Appendix E-3: Town of Oakville Consultation

Phase 1 & 2 Class EA – Navy and Water Street WWPS

Meeting with Town of Oakville

Halton Project No.:	PR-2831A	Date:	Thu. September 05, 2013
B&V Project No.:	181097	Time:	2:00 pm
Meeting Location:	Halton Region Office – North Service Road, Beech Room

ORIENTATION I

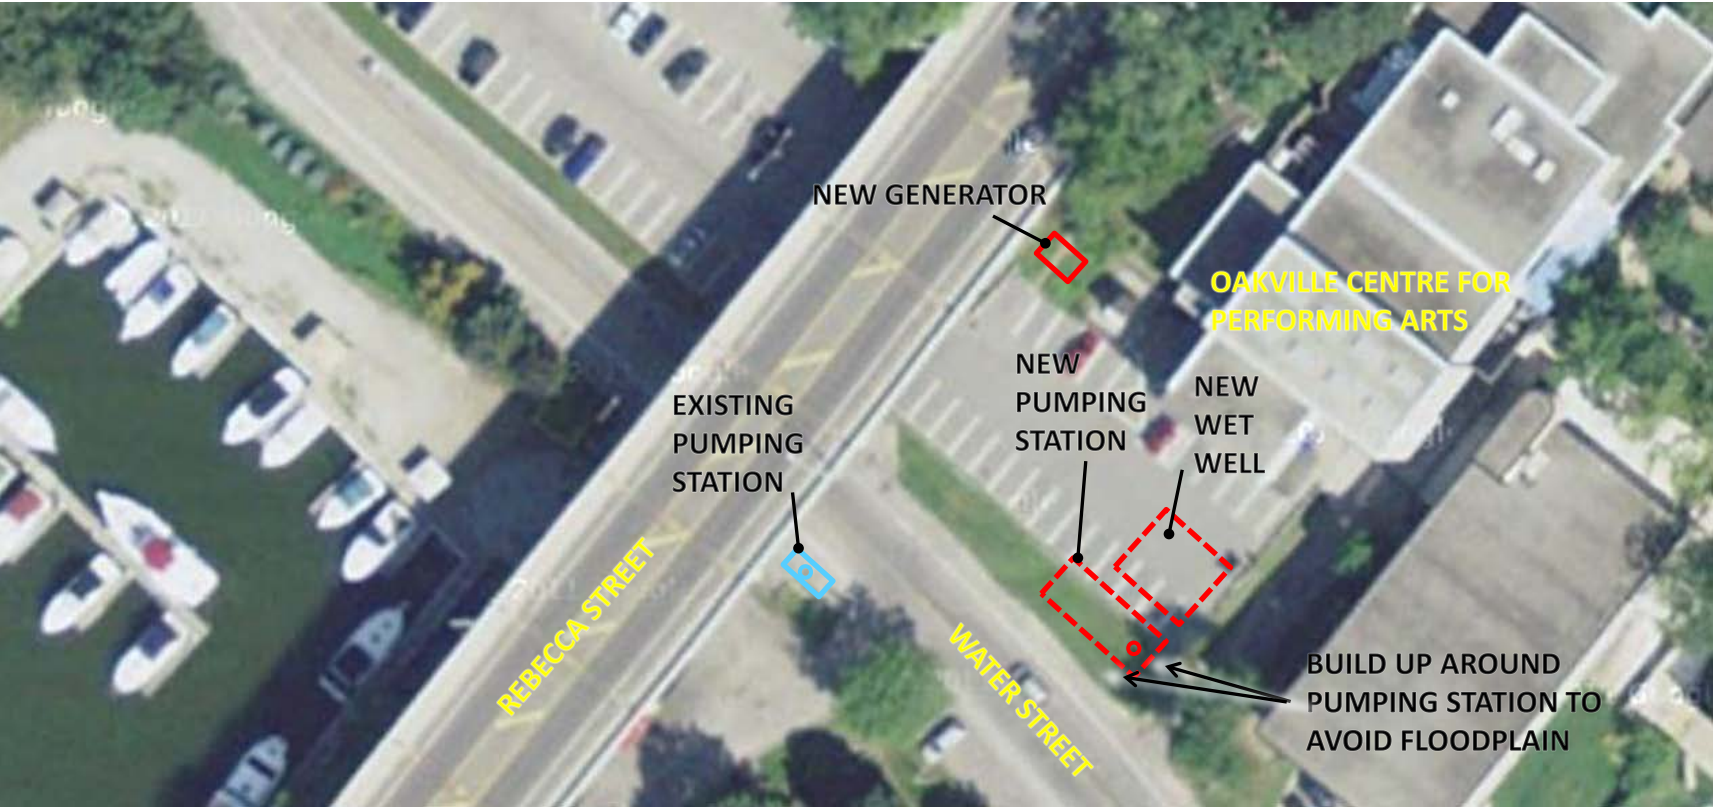
5.1	Alternative 2 is preliminary preferred alternative.	INFO
5.2	<p>WWPS location:</p> <ul style="list-style-type: none"> • Three possible orientations of new WWPS within OCPA parking lot presented • Preferred location for WWPS is north side of Rebecca St to minimize disruption to OCPA. 	INFO

5.2.1	A new access area to OCPA will be constructed where substation is currently located. Existing substation planned to be relocated further north along Rebecca St. New standby generator cannot be located adjacent to existing substation.	INFO

5.2.6	<p>The option of constructing the new WWPS under the Rebecca St bridge would be complicated as construction would need to take place around the bridge foundations. However, if the bridge is to be rebuilt this may become an option.</p>	INFO

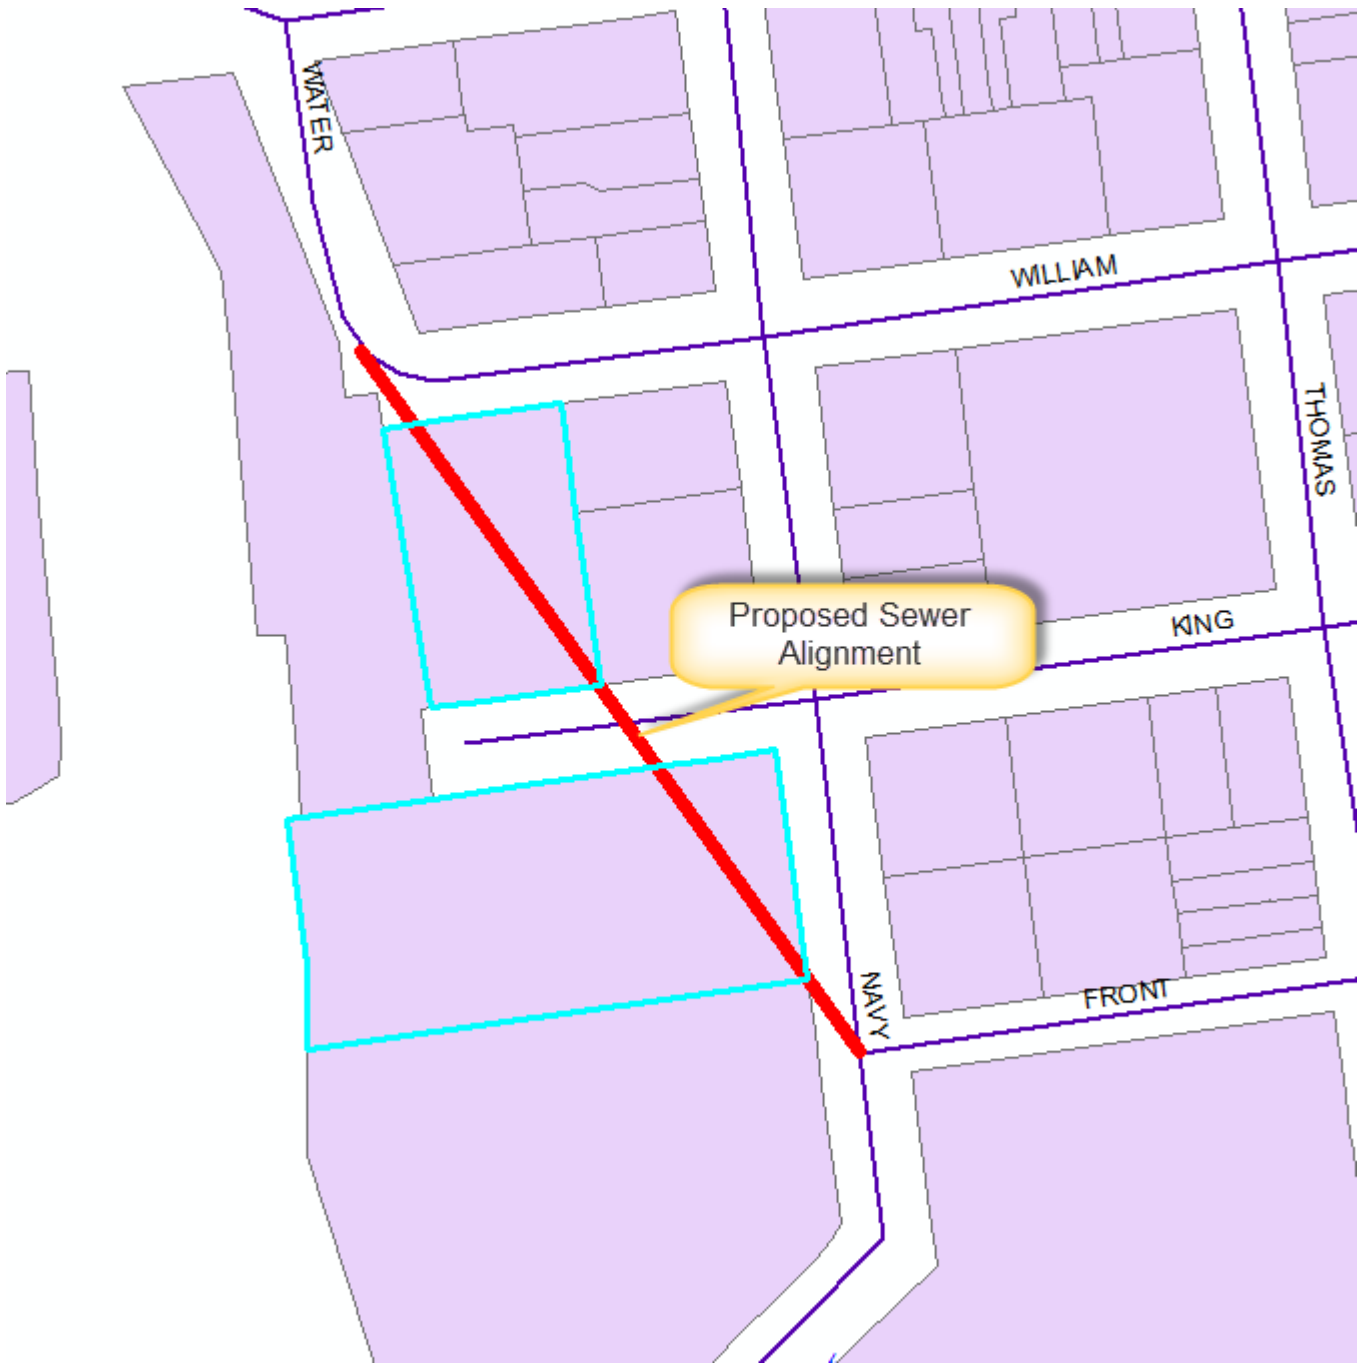
Good morning Keenan. Sorry to have been so long on responding and I thank you for the heads up. On first glance by our senior management, this proposal is recognized to likely to be a serious problem to us and at this time I can say without question that we are unlikely to support it. There are potentially some serious issues regarding the museum lands and certainly we do not want to sterilize our lands currently used by the Oakville Club as tennis courts. I assume that through the EA, we will be given the opportunity to make a formal presentation and in anticipation of this, we will continue consider the potential impacts.

We are in the early design stage of a sewer and Wastewater is kicking around an alignment option that would impact 2 Town properties (see below). The properties appear to be used for active and passive park areas and I am curious about what the Town's long term objectives for these parcels are. Halton would be directional drilling (TBM) for this section of the pipe at a depth of around 5m, so there would be no surface impacts. Notwithstanding this, the easement area bisects the one parcel and would effectively sterilize future development options.

This alignment option is cost effective for Halton, but hinges on the Town's perspective regarding these two properties. Have a look at the diagram below when you have some time and let me know your thoughts.

We have finally got comments back from the Town. They don't like your alignment proposal, so maybe we should book a meeting to review our options. I will leave it to you to arrange.

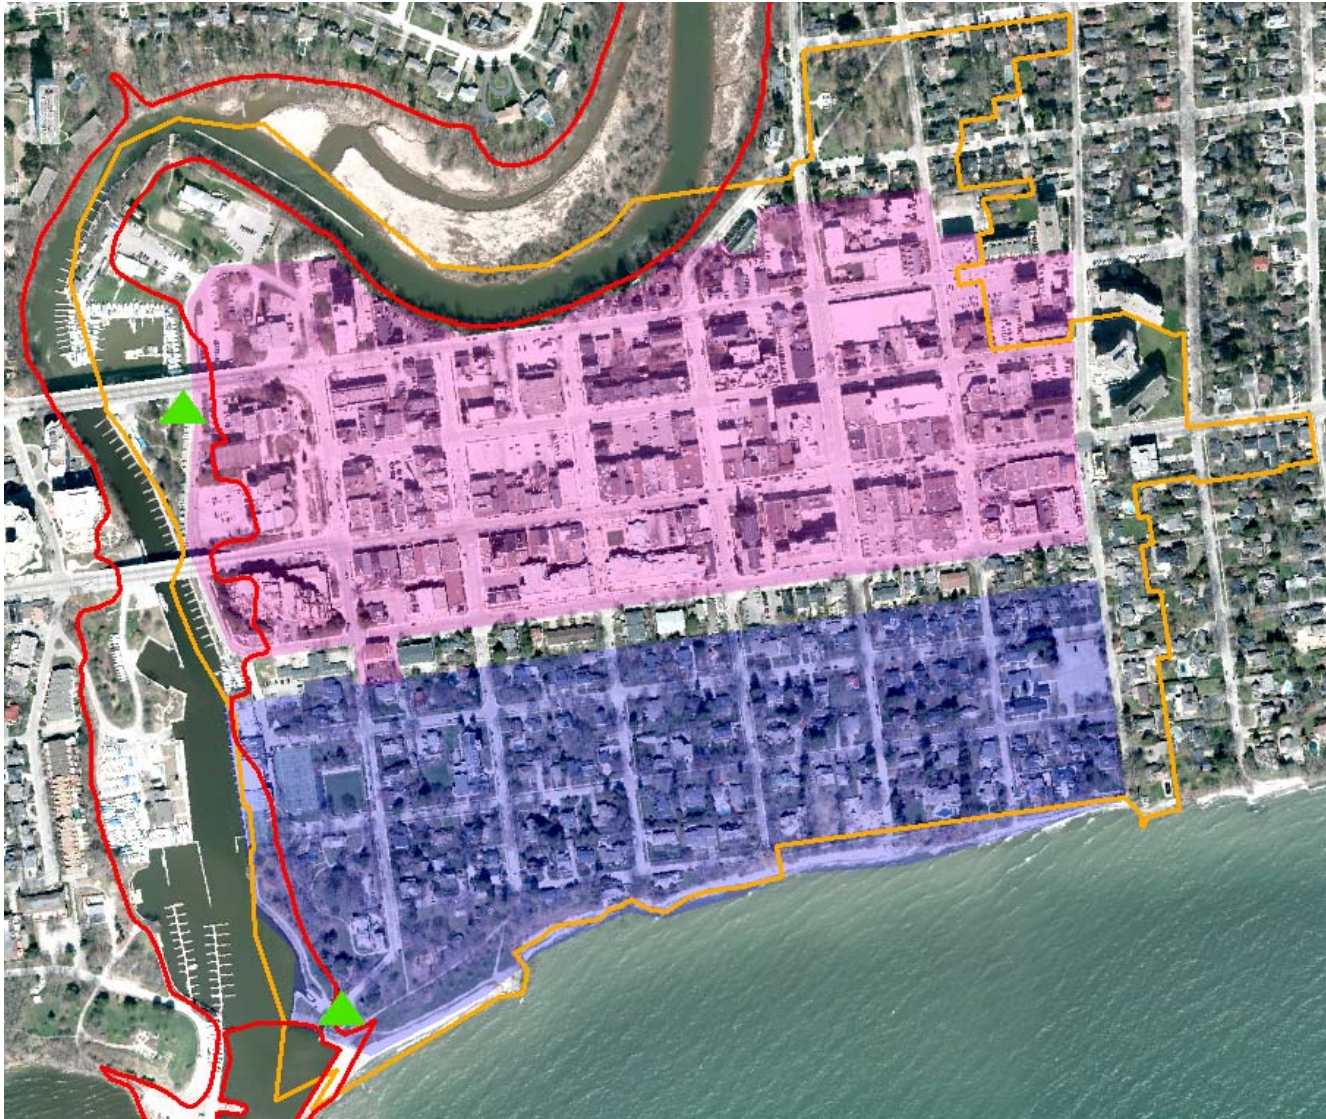
Staff met yesterday to review the revised proposal for the replacement pump station on Water Street. I've attached you second proposal with some slight modifications for your consideration. Our preferred option (Location A on the attached) is to see the new pump station moved slightly further north and west within the lands currently leased to the Power Boat Club. We are in the midst of revising the lease agreement with this long tenure client and we would like to

Aside from the pump station itself, I've gleaned back at some earlier PIC material and see that several routing options were reviewed for the gravity pipe from Front/Navy to this pump station. Can you advise me on the currently selected route and the planned method of installation (open cut vs bore) as staff would like to comment on this as well. Lastly can you please confirm timing for detailed design, construction and the expected duration of the project. Given the number of projects targeting our Downtown Core area, our Engineering department will be in touch to discuss the timing on the collection of projects and how to best coordinate the work in this area and minimize disruption.
